ADDENDUM NO. 1

Date:	February 7, 2011
To:	Contractors
From:	Jeff Reddoor
Reference:	Provo Juvenile Courts Animal Shelter Tenant Finish & Mechanical Administrative Office of the Courts - Provo, Utah Project No.10051150
Subject:	**Addendum No. 1**

PROVO JUVENILE COURTS-ANIMAL SHELTER - ADDENDUM NO. 1

PROJECT:	PROVO JUVENILE COURTS-ANIMAL SHELTER RENOVATION AND MECHANICAL UPGRADE DFCM PROJECT NO. 10051150 2200 SOUTH STATE STREET PROVO, UTAH 84606
ARCHITECT:	EDA ARCHITECTS INC. 9 EXHANGE PLACE, SUITE #1100 SALT LAKE CITY, UTAH 84111
DATE:	February 7, 2011
BID DATE:	February 16, 2011

1.1

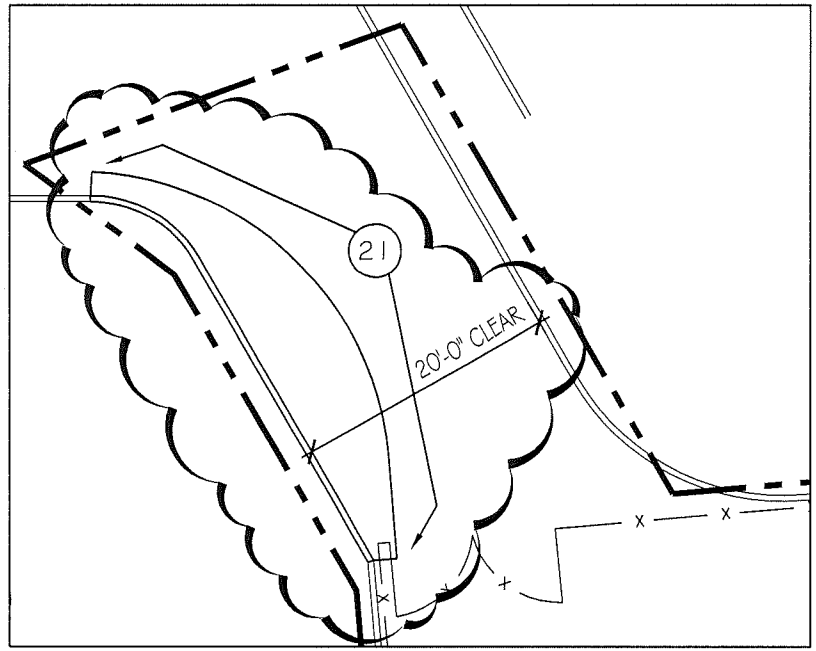
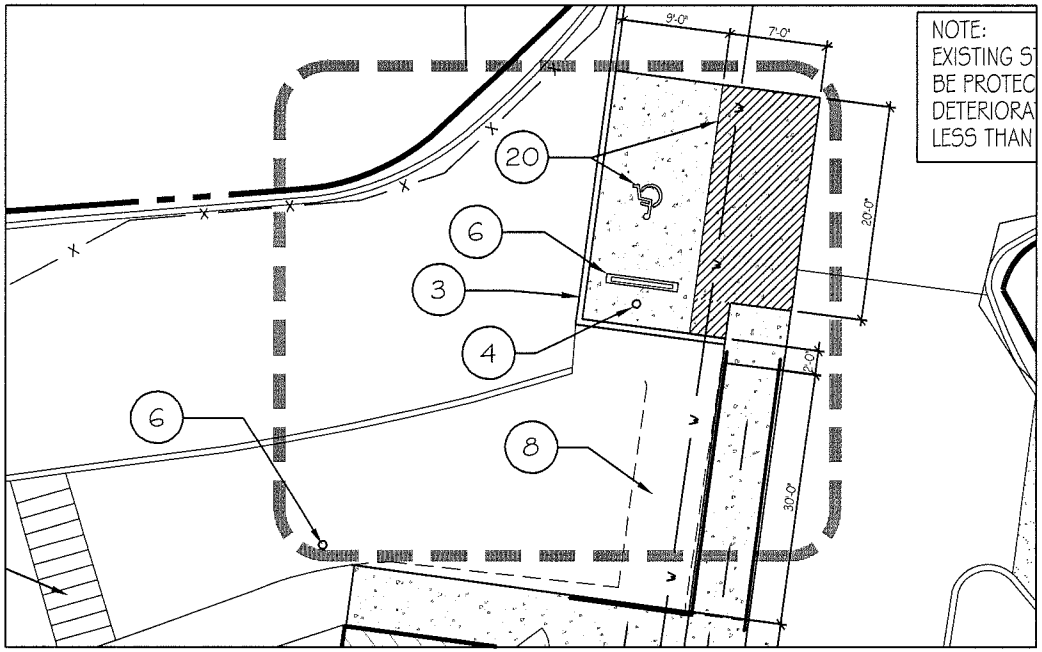
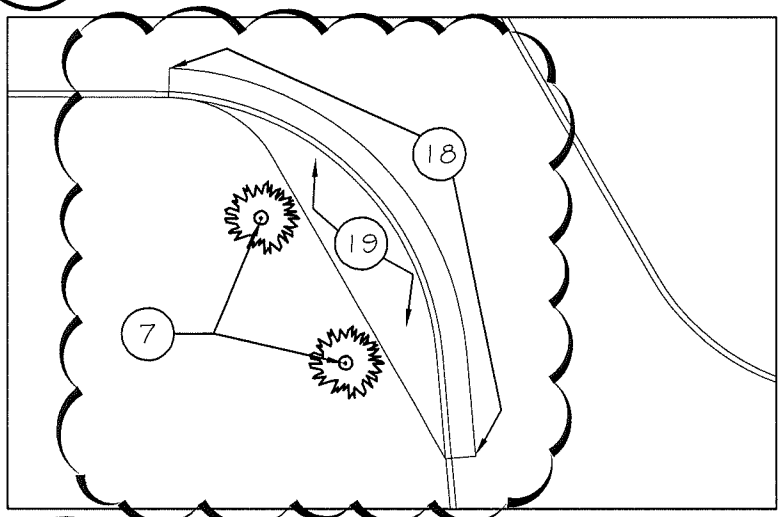
On the Revised Site Plan, change the enlarged plan reference from drawing no. "AS-001" to read drawing no. "AS-002".

On the revised site plan (2/AS-001), in the area outlined by the detail 3/AS-002 reference, change the keynote 6 reference to keynote 1 for the parking chuck call out. Also add the Keynote 3 for the new curb layout around the ADA parking area. See Attachment Addendum. 1.1 for this and other information related to drawing AS-001.

On the revised site plan (2/AS-001), the pauche for alternate # 2 extends all along the east side of the building and continues around to the south side as indicated.

For keynote 16, add "as part of Alternate #2" to the end of the key note.

ADDENDUM 1
1.2

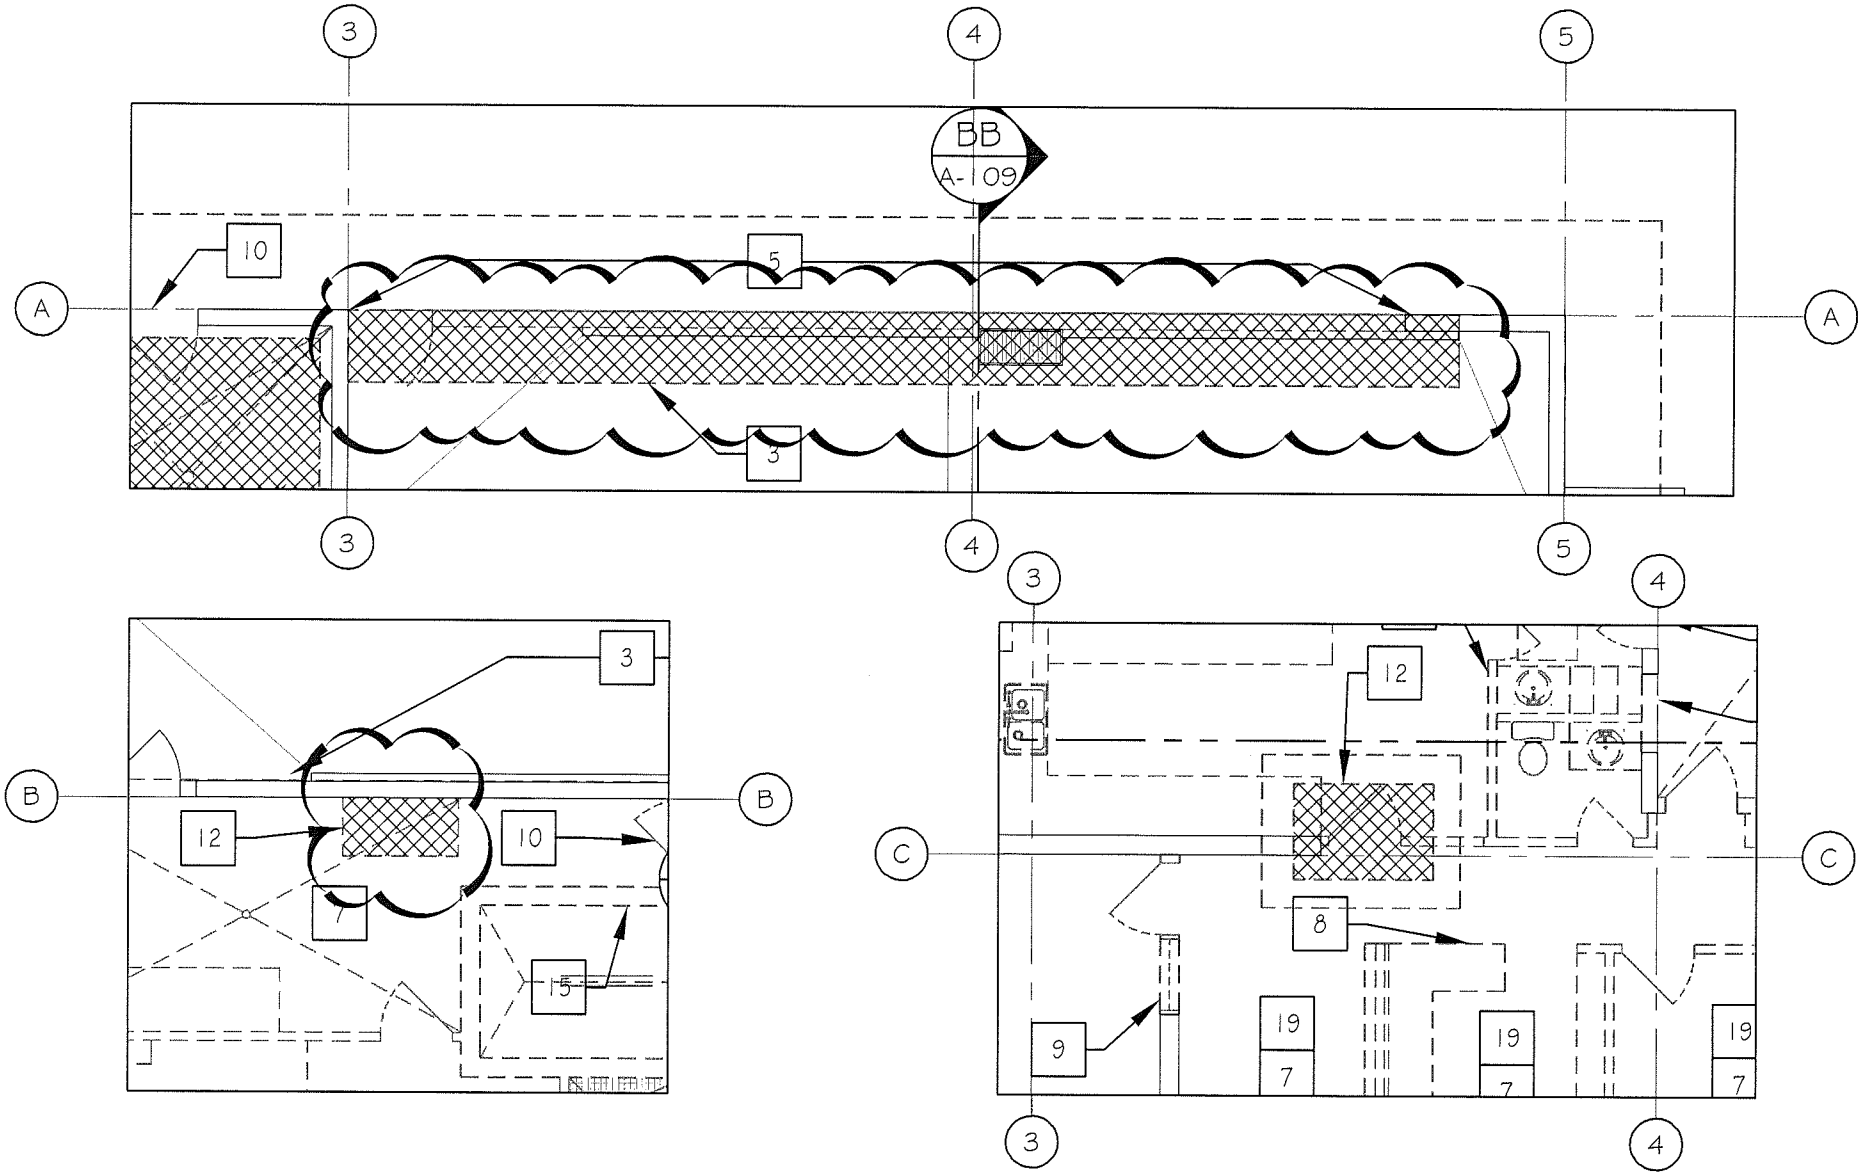
For clarity, see Attachment Addendum 1.2 for additional hatched areas of the floor slab to be removed .

Add new interior 4" concrete slab over drainage course in area identified to have concrete slab removed on drawing D-101 and Attachment Addendum 1.2.

1.3

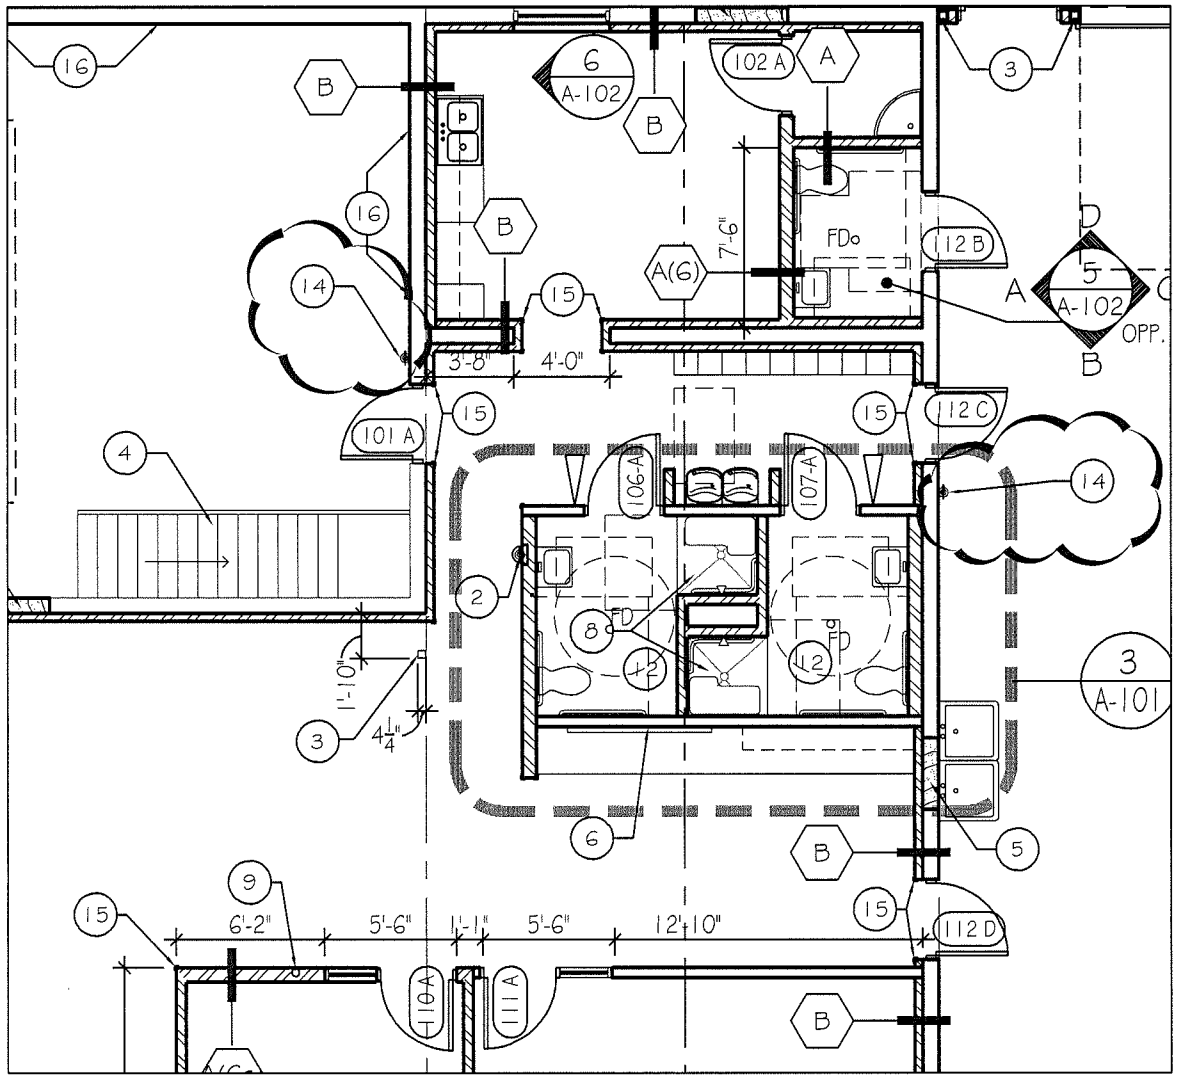
See attachment Addendum 1.3 for fire extinguisher location.

ADDENDUM 1.4

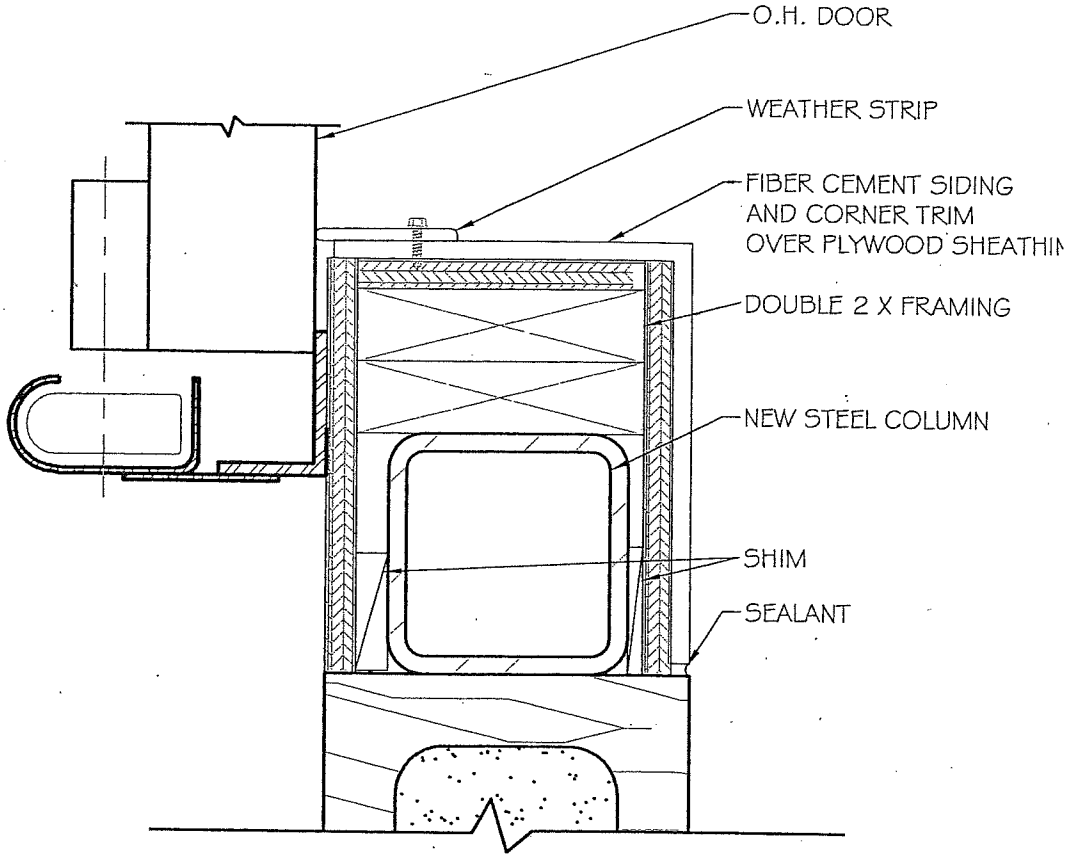
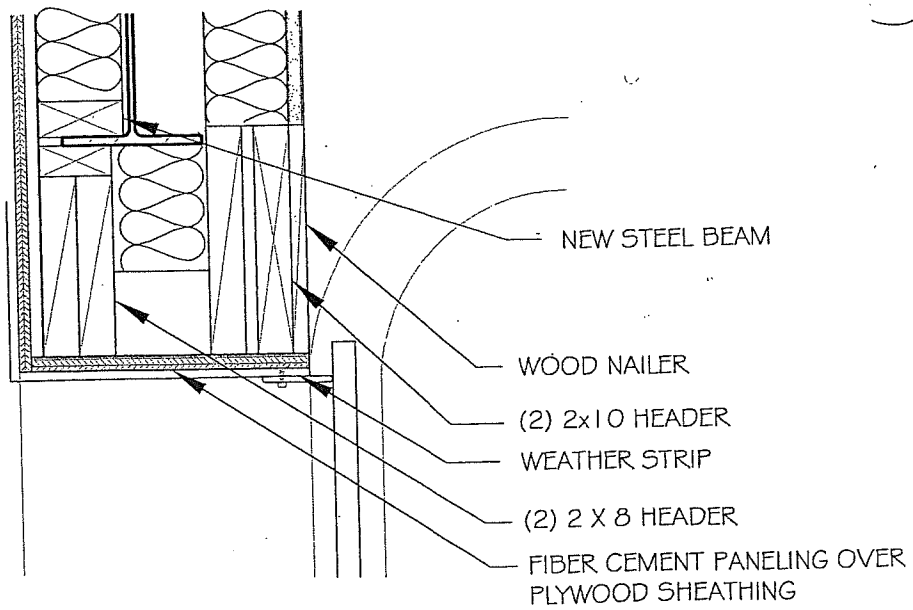
Delete details G/A-109 and F/A-109 and replace with details F and G on Attachment Addendum 1.4.

ADD-01
EE201

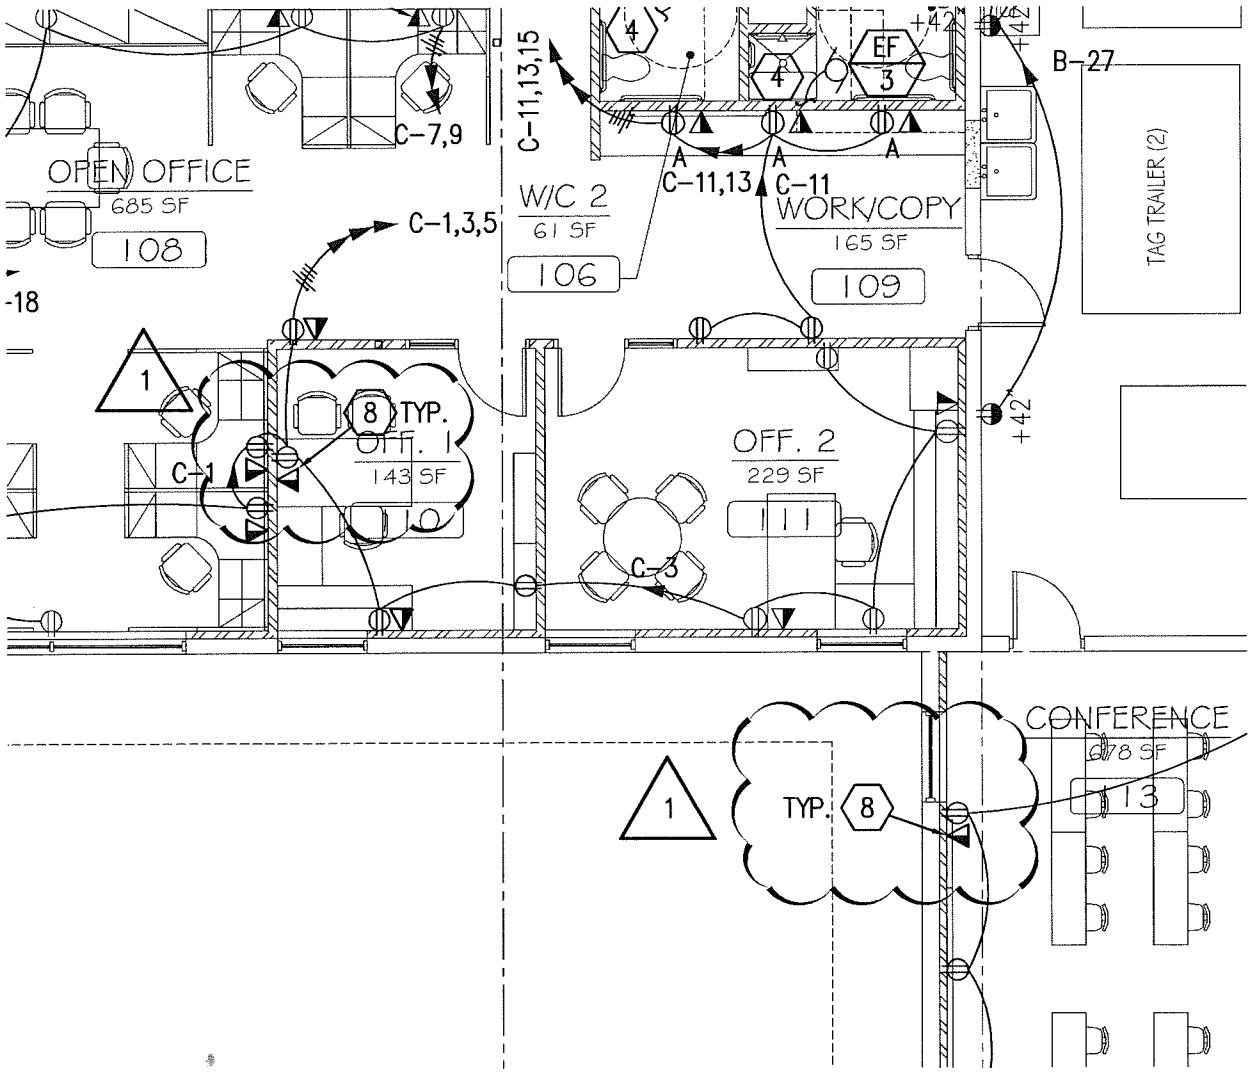
SHEET - E201
1. Keyed note 8 was added to reflect a 3/4 " conduit for each data outlet to the telephone terminal board.

8. PROVIDE 3/4" CONDUIT FROM DEVICE LOCATION TO THE TELEPHONE TERMINAL BOARD. TYPICAL FOR ALL DATA JUNCTION BOXES.
